□Urgent □Return receipt □Expand Group □Restricted □Prevent Copy
From: Michael Chi Kin SO/PLAND Sent: Tuesday, February 4, 2025 11:04 AM To: Cc: Gary Tat Leung LAM/PLAND < gtllam@pland.gov.hk > Subject: Re: [Departmental Comment] - Application No. A/YL-NSW/335
I refer to the captioned planning application. Please find the following departmental comments for your
follow-up action.
Fanling, Sheung Shui and Yuen Long East District Planning Office, Planning Department (Contact person Mr Gary LAM, tel: 3168 4043)

PROPOSED SWIMMING POOL DD104 LOT NO. 3725 S.A&S.B YUEN LONG, N.T

主旨: Re: [Departmental Comment] - Application No. A/YL-NSW/335

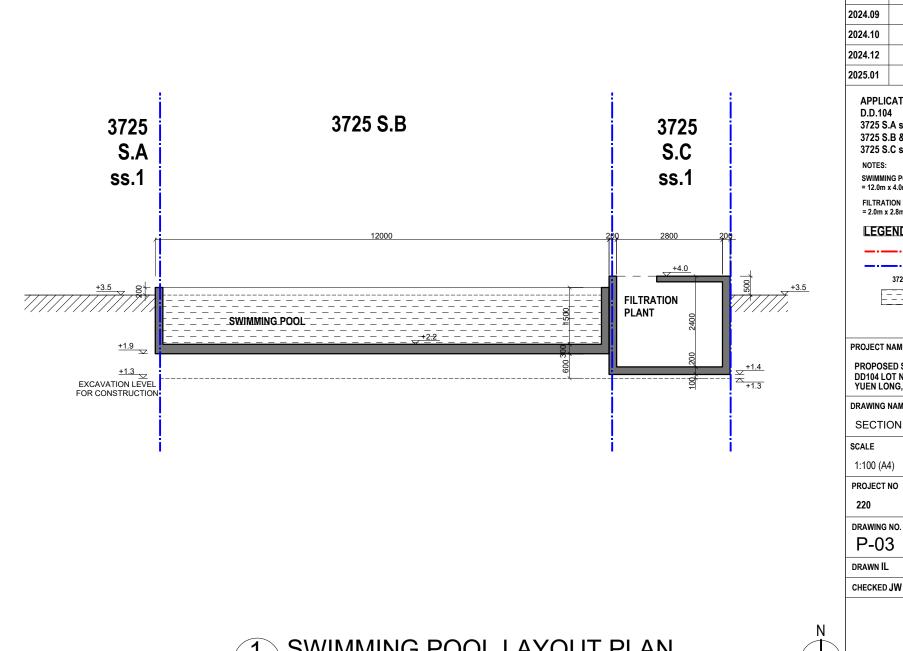
1. Please clarify the depth of excavation and purpose of excavation at the application site.
2. Please clarify whether there is any structure atop the filtration plant and whether such structure forms part of the application. Plans and sections should be updated as appropriate.
Best Regards,
Michael SO
FS&YLE DPO, PlanD
Tel: 3907 0963
From: Sent: Monday, February 3, 2025 9:37 PM To: Michael Chi Kin SO/PLAND <mckso@pland.gov.hk> Cc: Gary Tat Leung LAM/PLAND <gtllam@pland.gov.hk>; Yen PY LEUNG/PLAND <pyleung@pland.gov.hk> Subject: Re: [Departmental Comment] - Application No. A/YL-NSW/335</pyleung@pland.gov.hk></gtllam@pland.gov.hk></mckso@pland.gov.hk>
Dear Mr. So,

Appoint 1				
□Urgent □Return receipt □	□Urgent □Return receipt □Expand Group □Restricted □Prevent Copy				
Michael Chi Kin SO/PLAND					
寄件者: 寄件日期: 收件者: 副本: 主旨: 附件:	2025年02月05日星期三 21:49 Michael Chi Kin SO/PLAND Gary Tat Leung LAM/PLAND Re: [Departmental Comment] - Application No. A/YL-NSW/335 SWIMMING POOL_REVISED SET_R3-3.pdf				
類別:	Internet Email				
Dear Mr. So,					
	Long East District Planning Office, Planning Department (Contact person:				
Mr Gary LAM, tel: 3168 4043) 1. Please clarify the depth of excavation and purpose of excavation at the application site.					
Please see attached R3-3 pl swimming pool.	an for the depth of excavation, the purpose is to build the

•	ere is any structure atop the filtration plant and whether such structure Plans and sections should be updated as appropriate.				
There is no structure atop of	f the filtration plant now.				
Comments of the Director of E	Environmental Protection (Contact person: Mr Kelvin WONG, tel: 2835				
existing storm water drains. Plo	provided, filtered swimming pool water is expected to be discharged into ease clarify the discharge arrangement of the potential ne filtration plant of the swimming pool.				
We refer to the comments of EPD (Mr. Kelvin WONG), we wish to clarify as follows:

P-04 REV.F

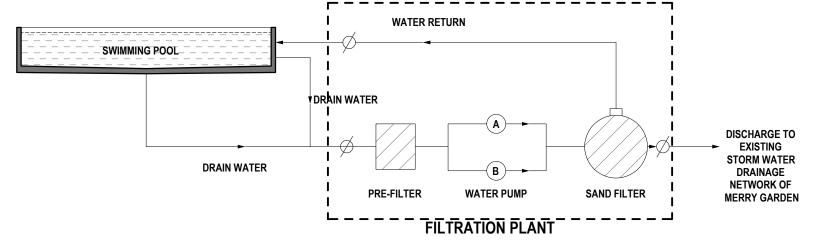
1. Based on the information provided, filtered swimming pool water is expected to be discharged into existing storm water drains. Please clarify the discharge arrangement of the potential wastewater(backwash) from the filtration plant of the swimming pool.
Grateful if you could provide your response <u>together with</u> the response regarding the comments I sent to you in preceding email <u>on or before 6.2.2025 (Thursday</u>). Many thanks!
Best Regards,
Michael SO
FS&YLE DPO, PlanD
Tel: 3907 0963

Urgent □Return receipt □Expand Group □Restricted □Prevent Copy Comment from Director of Environmental Protection (Contact person: Mr Kelvin WONG, tel:
2835 1117)
The applicant should clarify the discharge and/or handling arrangement of swimming pool water and backwash from the filtration plant.
Best Regards,
Michael SO
FS&YLE DPO, PlanD
Tel: 3907 0963

1. Filtered swimming pool water will be discharged to public rainwater drainage pipe network of Merry

Garden, and

□Urgent □Return receipt □Expand Group □Restricted □Prevent Copy 2. Filtration Plant backwash from filter tank will be discharged to the septic tank of the Village House no. 51 (Applicant's House), and that
the drainage system of swimming pool drainage shall be designed in accordance with Practice Note no. ProPECC PN 1/23 of Environmental Protection Department.
Best Regards,
Allgain Land Administrators Co
On Wed, 5 Feb 2025 at 17:02, Michael Chi Kin SO/PLAND < mckso@pland.gov.hk > wrote:
I refer to the captioned planning application. Please find the following departmental comments for your follow-up action.
Comments of the Director of Environmental Protection (Contact person: Mr Kelvin WONG, tel: 2835 1117)
